Device TC37xEXT
Marking/Step (E)ES-AB, AB
Package see Data Sheet

10297AERRA

This Errata Sheet describes the deviations from the current user documentation.

Figure 4 Message RAM Configurations

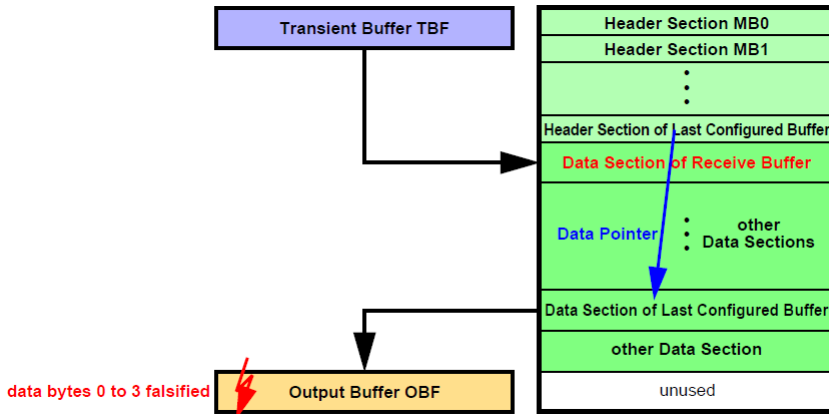
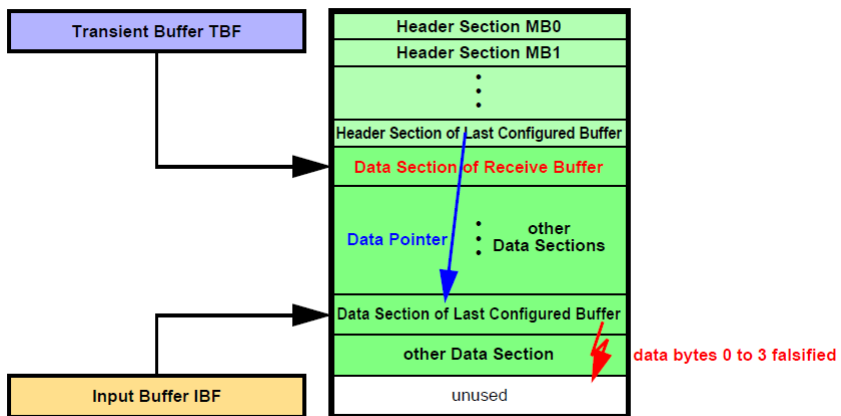
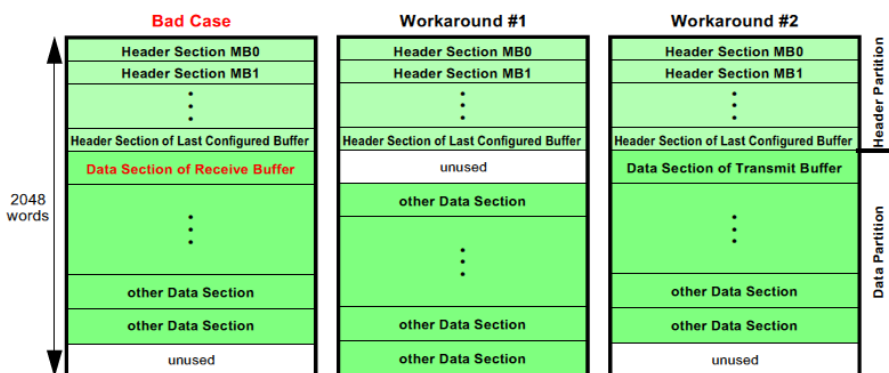
- a) When a message is transferred from the Last Configured Buffer in the Message RAM to the OBF and **PLC** = 127 it may happen, that at the end of the transfer the OBF word on address 00h (payload data bytes 0 to 3) is overwritten with unexpected data (see [Figure 2](#)).
- b) When a message is transferred from IBF to the Last Configured Buffer in the Message RAM, it may happen, that at the end of the transfer of the Data Section one additional write access overwrites the following word, which may be the first word of another message's Data Section in the Message RAM (see [Figure 3](#)).

2) Ensure that the Data Section directly following the Header Partition is assigned to a transmit buffer.

Figure 7 Critical MCS AEI master scenario

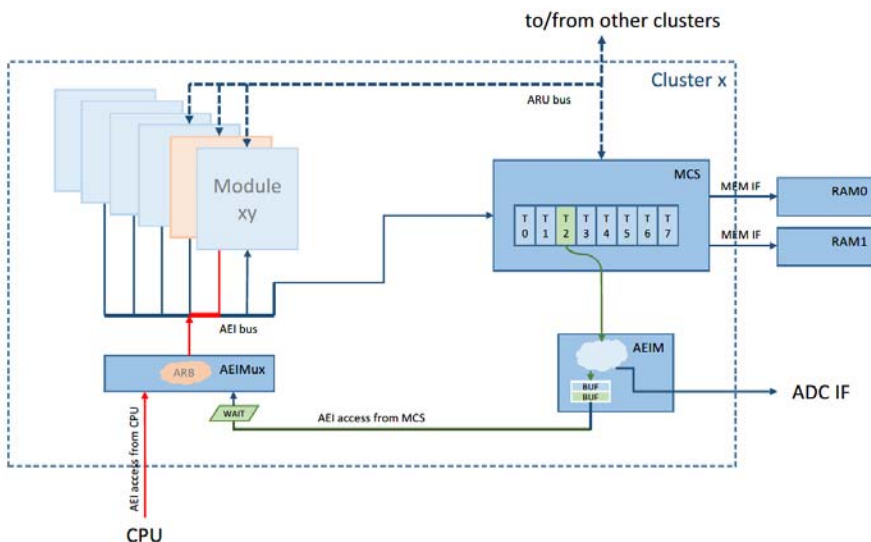
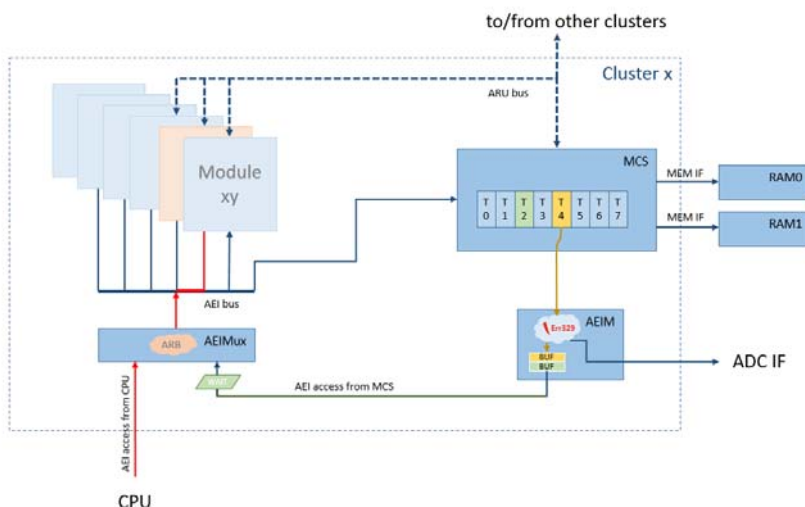
To avoid the potential occurrence of problem GTM_AI.329 it has to be ensured that not more than 1 AEIM buffer gets filled due to backpressure in the AEI bus system.

In [Figure 7](#), a potential risk for the occurrence of problem GTM_AI.329 is illustrated. Here the first buffer of the AEIM (green) is still waiting for the access to the AEI bus while a second AEI bus access from MCS arrives at the AEIM (yellow access path). Under certain, but for the user unpredictable timing conditions, this second AEI bus access arriving at the AEIM can trigger the misbehavior described in problem GTM_AI.329.

The workarounds described in the following section will ensure that not more than one AEIM buffer will be filled and therefore the occurrence of problem GTM_AI.329 is avoided. All workarounds have been tested and proven correct.

Figure 8 MCS token mechanism

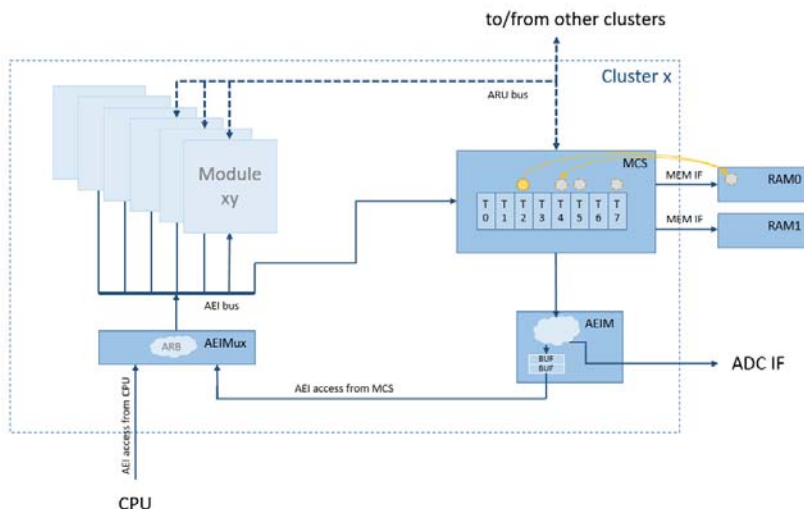
In case multiple MCS channels want to use the AEI master port for AEI or ADC communication, establish a mechanism that ensures that only one channel uses the AEI master at a time (e.g. exchange a token between channels or use trigger registers to hand over the AEI master port ownership between MCS channels).

An application note (AN020 – MCS Mutex implementation) describing a token exchange mechanism between MCS threads is available at Bosch. Such a token mechanism allows multiple MCS threads to safely access the AEI bus system by exchanging an AEI bus access token via MCS memory.

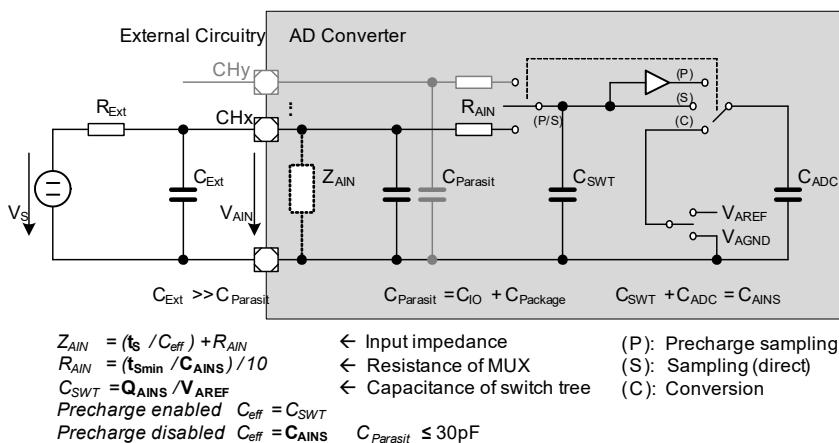
When using the alternate reference (G10CH0) for conversions on channels of converter group G10, the Total Unadjusted Error (TUE) of the conversion results may increase with temperature

- up to $\pm 12 \text{ LSB}_{12}$ for operation with converter reference clock $f_{\text{ADCI}} = 32 \text{ MHz}$.
- up to $\pm 25 \text{ LSB}_{12}$ for operation with converter reference clock $f_{\text{ADCI}} = 40 \text{ MHz}$.
- up to $\pm 46 \text{ LSB}_{12}$ for operation with converter reference clock $f_{\text{ADCI}} = 53.33 \text{ MHz}$.

Note: This problem will not occur in the lower range of the ADC analog supply voltage ($V_{\text{DDM}} < 4.5 \text{ V}$), as f_{ADCI} is limited to 26.67 MHz in this case (see Data Sheet).

Figure 10 Interrupt Level vs. Pulse-Notify mode - Corner Case Example

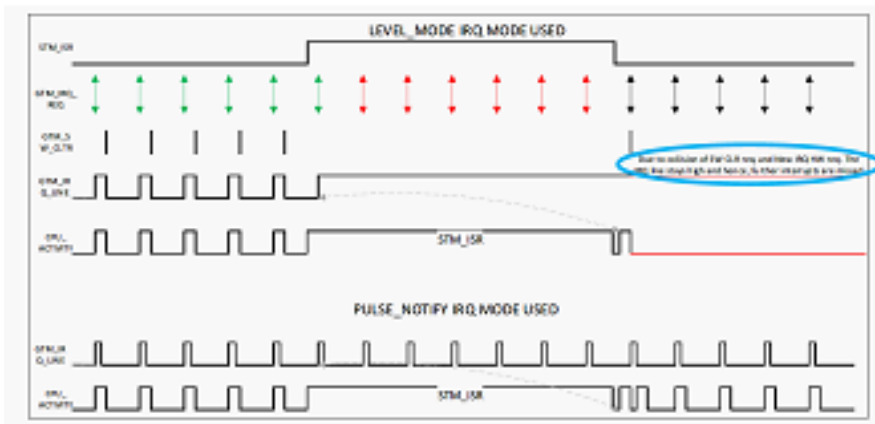
Hence, in Level Mode, in some scenarios where another interrupt request is generated by GTM while the ISR handle also requests a SW clear, then, as the interrupt event is dominant over the clear event (for simultaneous interrupt and clear events), GTM_IRQ_XXX is not cleared and remains high. As a consequence, the IR observes no transition on GTM_IRQ_XX. Thus, any forthcoming interrupt events in this scenario are lost as there is no chance to release the CPU IRQ when a collision happens as shown in Figure below.

If Pulse-Notify mode is selected, every internal trigger will be forwarded to the IR, irrespective of the time of occurrence and the clear event, as the pulse-notify leads to set and reset of GTM_IRQ_XXX as compared to only setting of the GTM_IRQ_XXX line in Level mode.

Figure 12 Timing of LVDS TX interface command sending in relation to IRQ.IFCFS

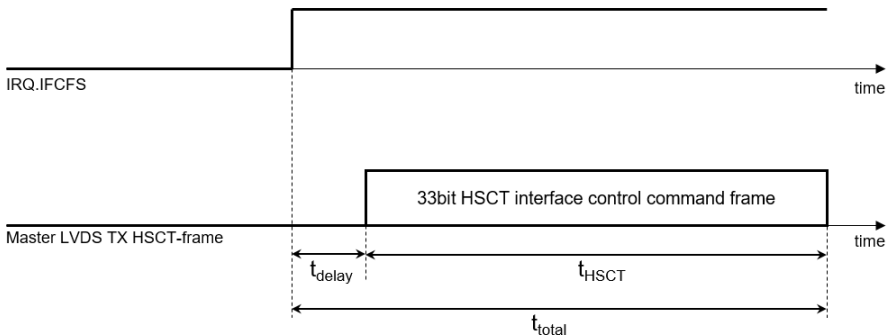
the user might falsely assume that also the actual sending on the LVDS TX port has already occurred once the IRQ.IFCFS flag is set, which is not true.

Instead the timing shown in **Figure 12** applies.

Figure 13 SDIO Card Interrupt Sequence

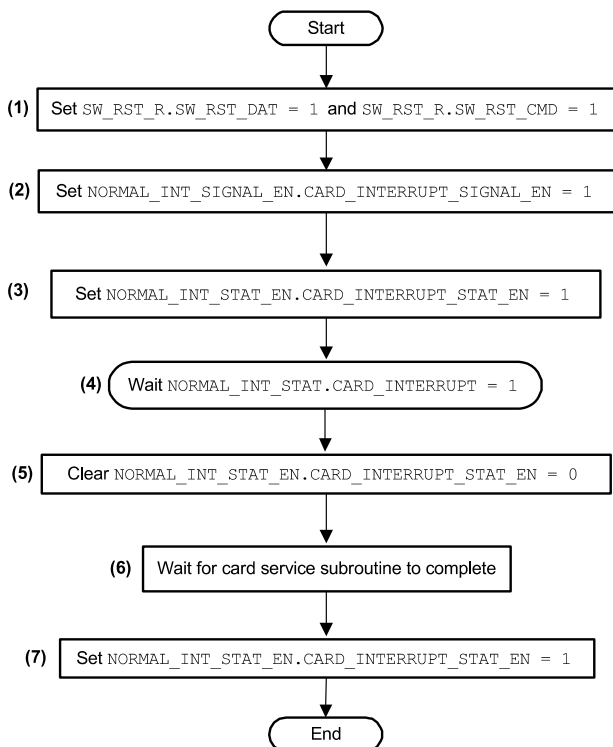
Figure “SDIO Card Interrupt Sequence” in the SDMMC chapter of the current version of the TC3xx User’s Manual is wrong. The correct sequence is shown in the following **Figure 13**.
